Process Sheet

Customer : CU-DAR001 Dart Helicopters Services	Drawing Name : HELI UTILITY BASKET LH/RH 350/355
Job Number : 37551	
Estimate Number : 10208	
P.O. Number :	Part Number : D350607043
This Issue : 2/20/2008 S.O. No. :	Drawing Number : D350-607 REV F P7-9
Prsht Rev. : NC	Project Number : N/A
First Issue : / / Type : LARGE FAB ASSY	Drawing Revision : F
Previous Run : 37513	Material :
Written By :	Due Date : 3/20/2008 Qty: 1 Um: Each
Checked & Approved By : <u>080221</u>	
Comment : Est Rev:E as Per DSI9318 06-01-24 JLM	
Est Rev:F ECN1068 07-12-21 DD verified by:

DART SERVICE INSTRUCTION

To reduce the possibility of damaging the finish, a **NAS1515H4** washer (2 places) has been added between the hinge plate and basket frame on the **D350-607-043/-047 Heli-Utility-Basket**.

DESIGN BW	DRAWN BY PH	DART AEROSPACE LTD HAWKESBURY, ONTARIO, CANADA	
CHECKED [Signature]	APPROVED [Signature]	DRAWING NO. D2221	REV. F SHEET 3 OF 3
DATE 05.06.07	TITLE BASKET BASE ASSEMBLY (350)		SCALE 1:8

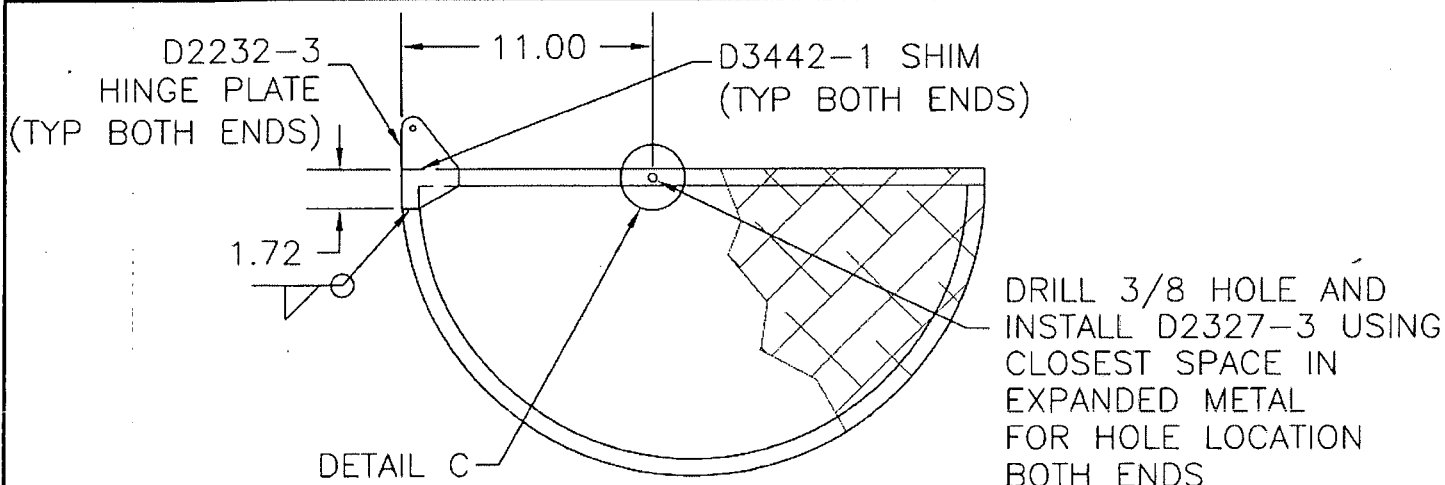
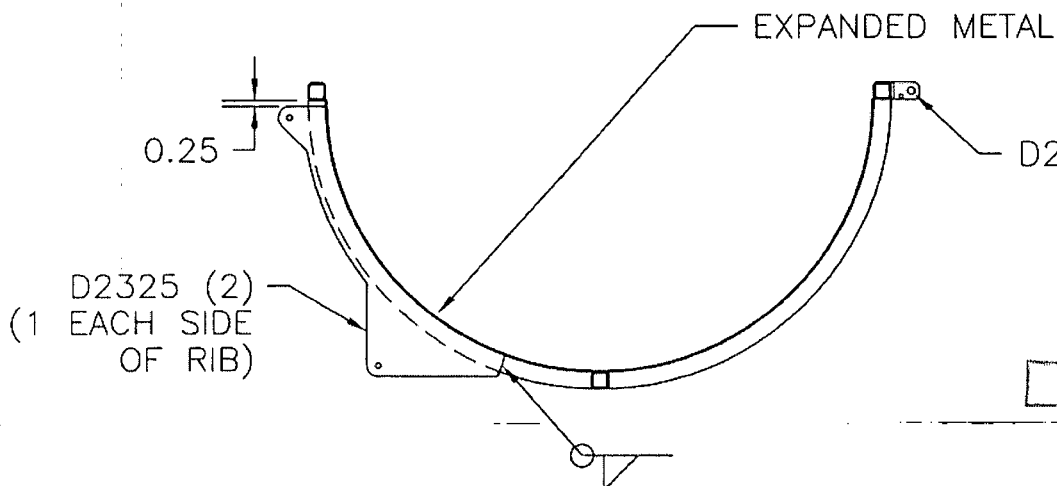
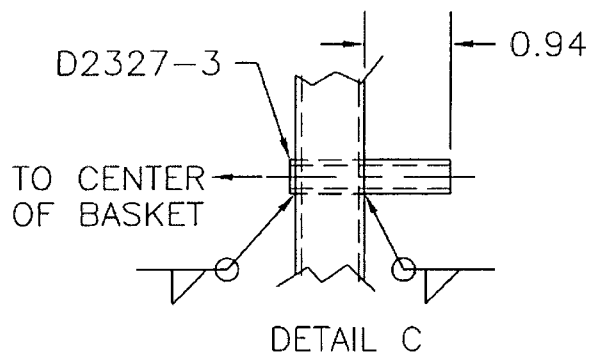
08-02-05 PH
TUBING TO BE
CHANGED TO 0.065
WALL
PH 08-02-21

DESIGN	DRAWN BY	DART AEROSPACE LTD VICTORIA INTERNATIONAL AIRPORT, CANADA	
B WILLIAMS	B WILLIAMS	DRAWING NO.	REV. B
CHECKED	APPROVED	D2235	SHEET 1 OF 1
DATE	TITLE		SCALE
94:12:16	BASKET RIBS

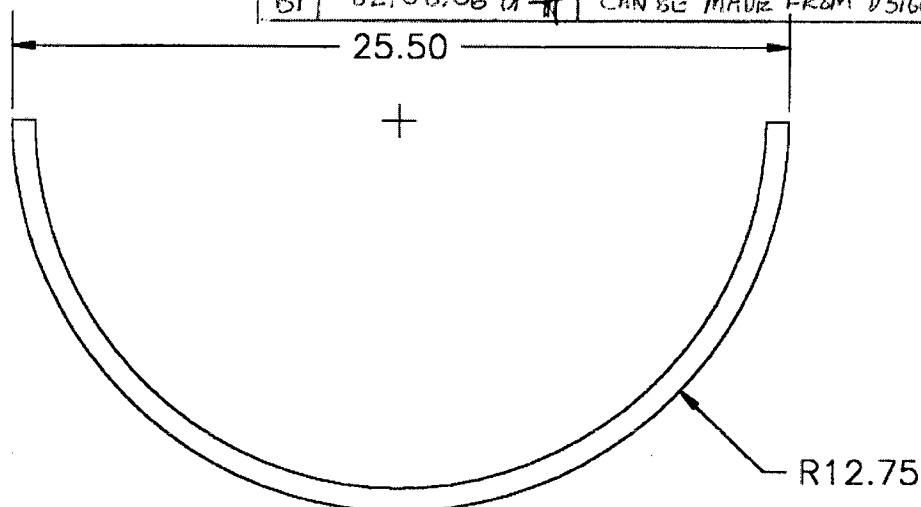
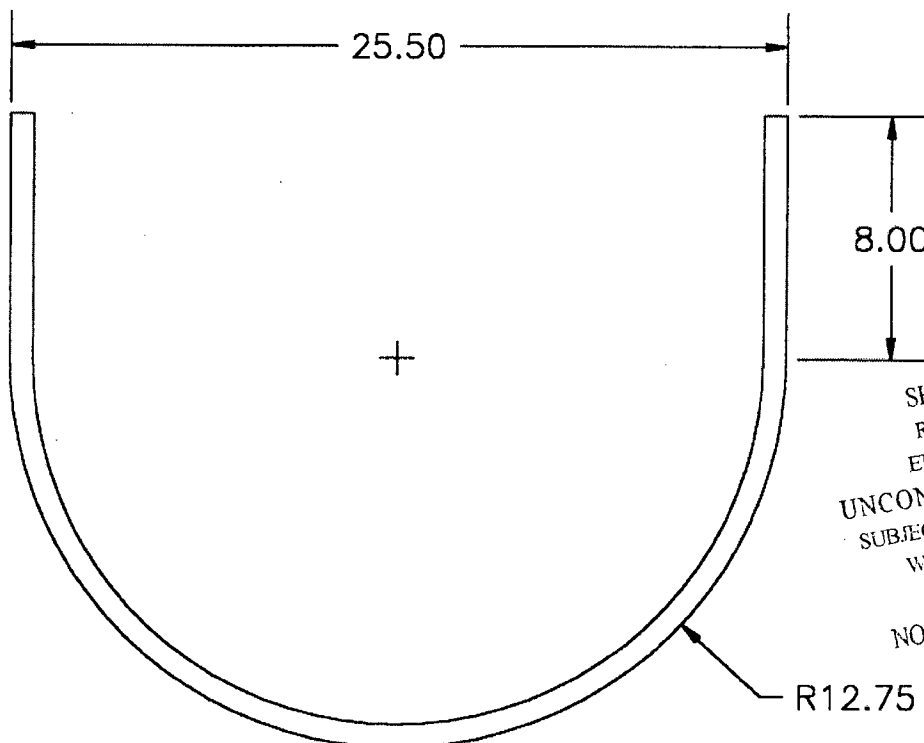
BI 02.08.06 *UP#* CAN BE MADE FROM D3166-1
